Appendix A
Responses to
Consultees' Comments

Charlton Riverside Ref: 16/408/F

Anchor and Hope Lane Sites

Response to Consultee Comments

Proposed root plan with future E - W route
 (20m corridor)

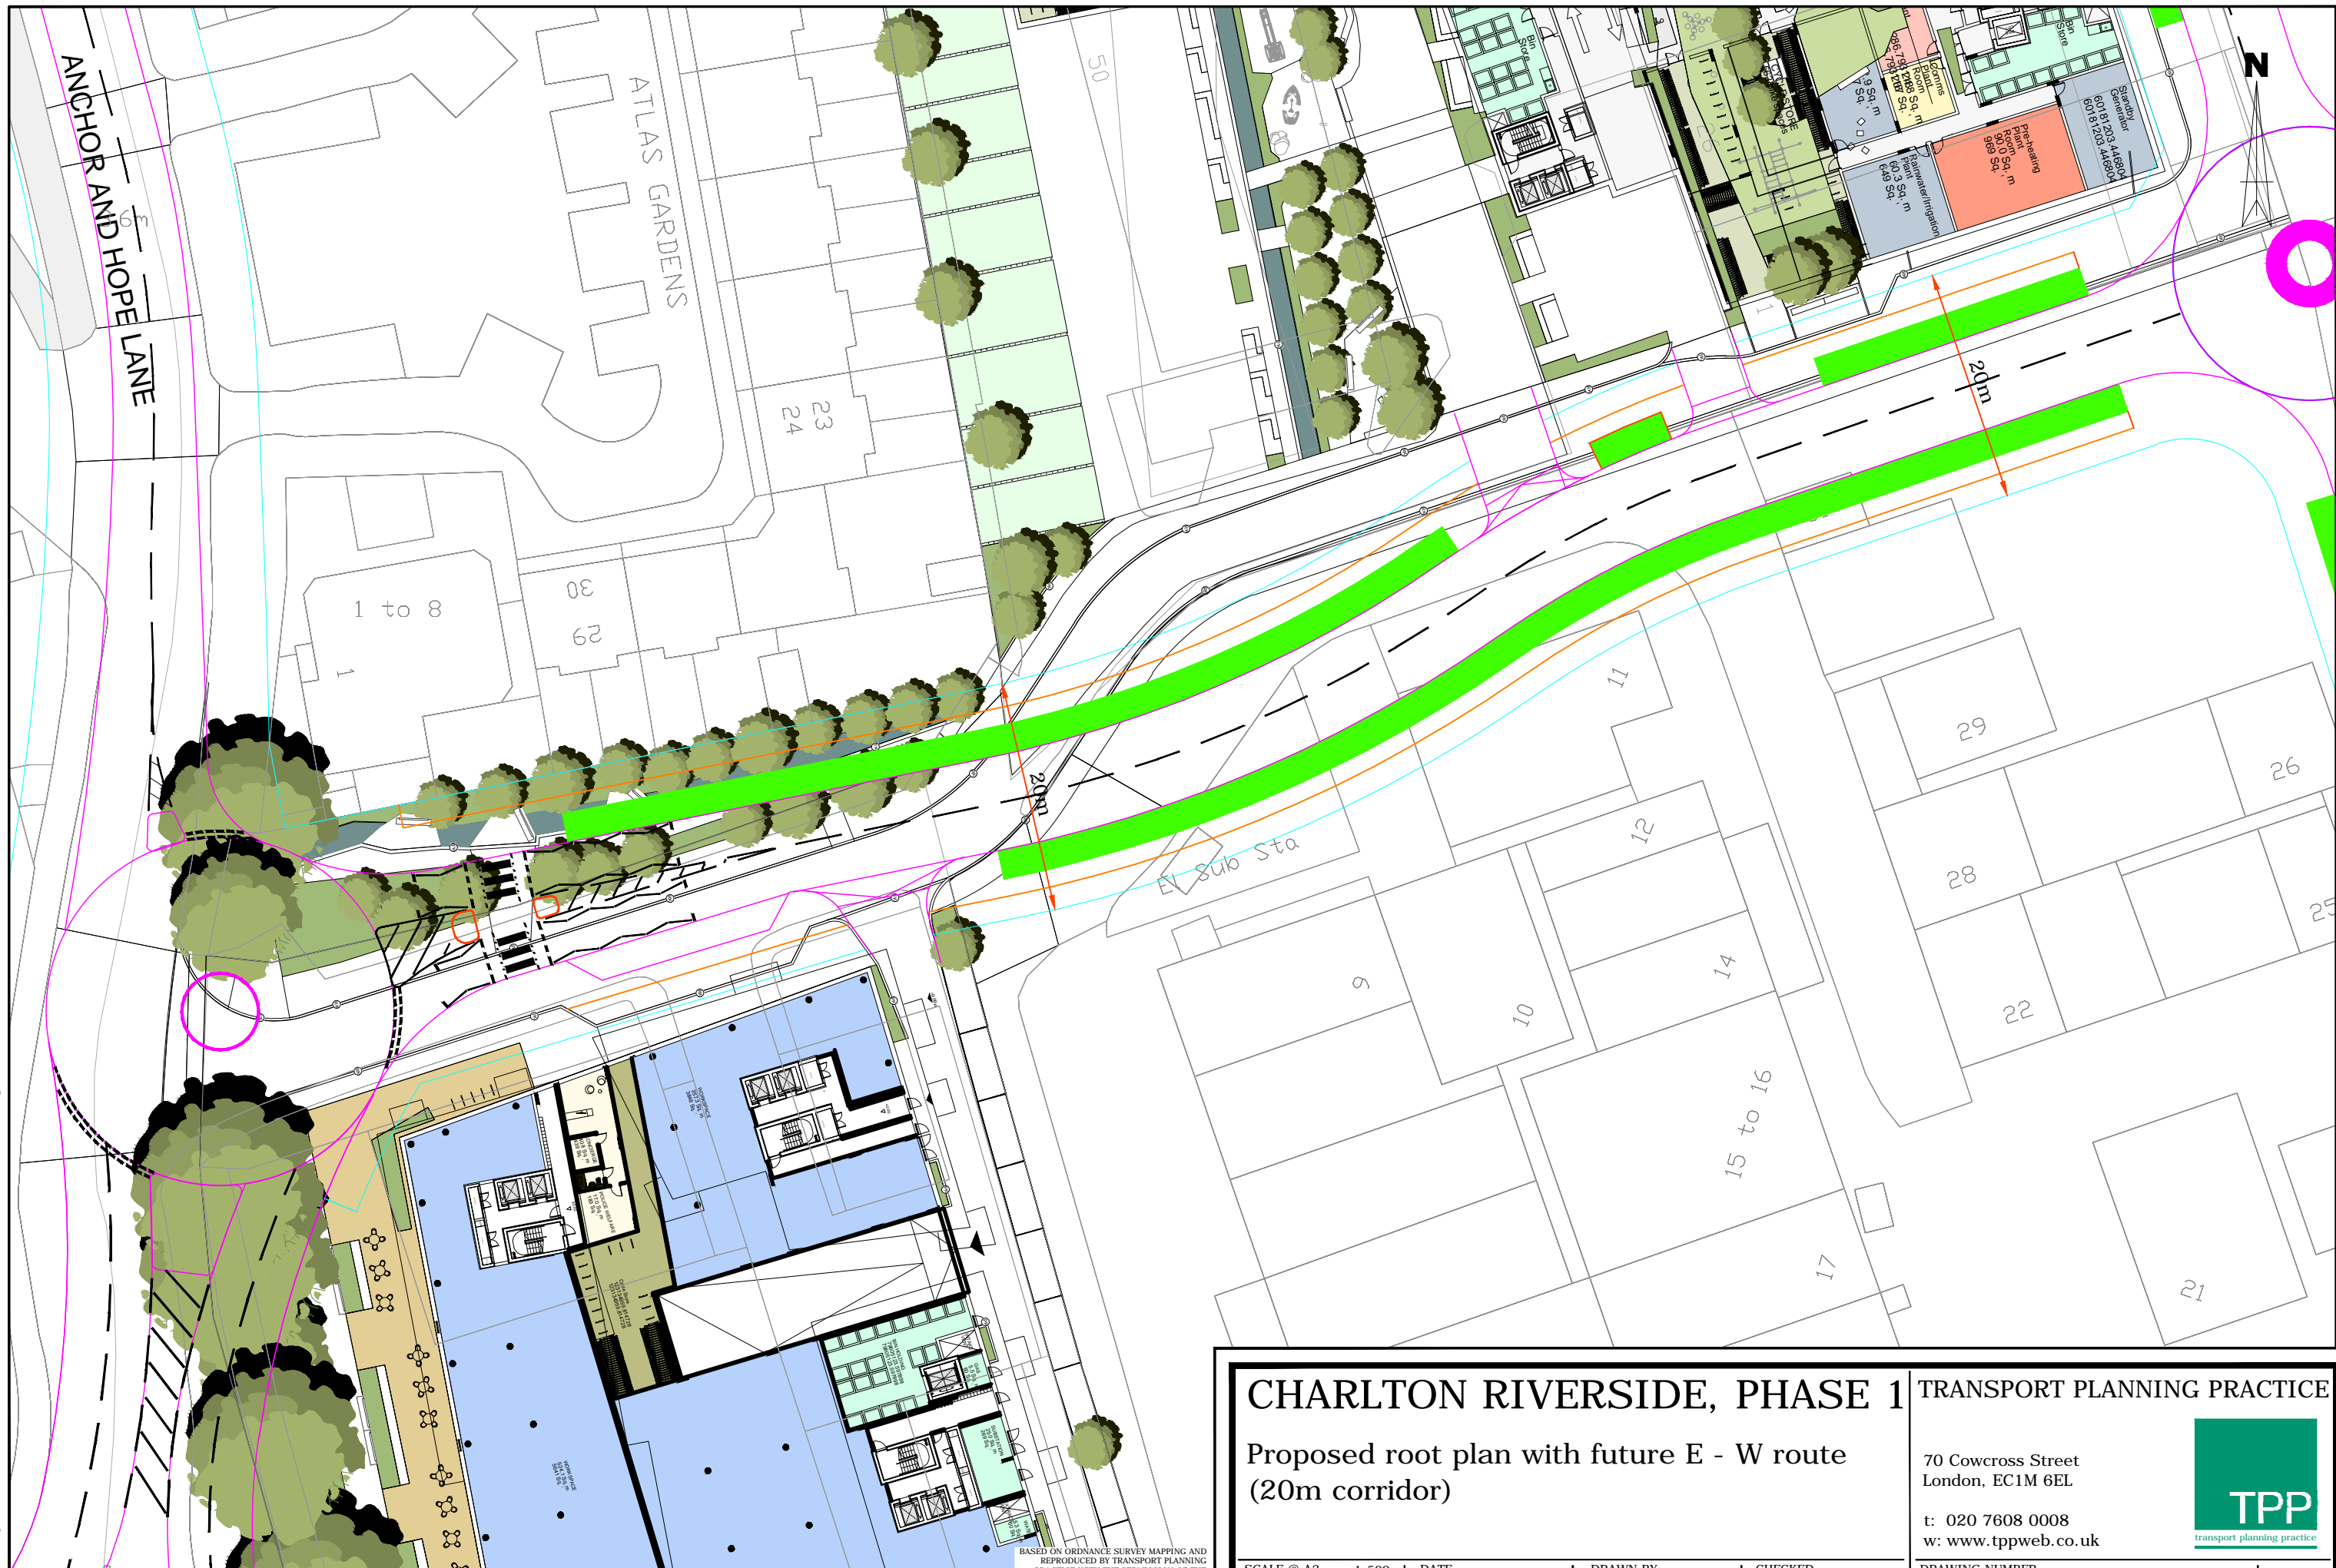
2. RBG have requested that it should be demonstrated that the East-West route through between the two plots (a 20m road corridor) can be delivered at a later stage when the wider Charlton Riverside masterplan is implemented.

3. The development proposals for the site have always been cognisant of the wider Charlton Riverside Masterplan and have been developed around a general framework of highway infrastructure. As neither RBG nor their appointed masterplan team have prepared a sufficiently detailed drawing the applicant has prepared such a plan to enable the preparation of development schemes on their plots. TPP Drawing Numbered 30821/AC/217 indicates the provision of a 20m highway corridor in the vicinity of the application site.
